**REQUEST FOR TENDER  
RFP #2019-074-AC ADDENDUM #3**

**New Crime Scene Lab Building (Forensics Training Facility)**

October 9, 2019

OPSD 1006.010

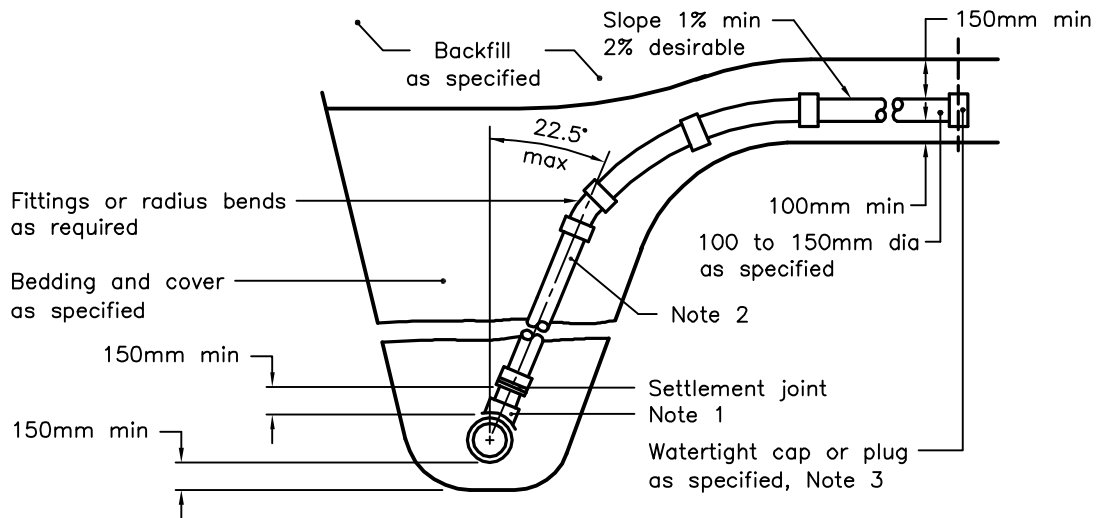
1. The work of division 15 includes the work of installing the water and sanitary connections as follows:
  - a. Water Connection: All work required to provide the 1" water connection from the adjacent Otonabee College Residence building, including hole drilling/filling, system isolation/draining, shut-off valve installation, pipe insulation, etc.
  - b. Sanitary Connection: All work required to connect the new 4" sanitary drain to the existing sanitary sewer on East Bank Drive, including teeing into the existing sewer as per OPSD 1006.010 (attached).
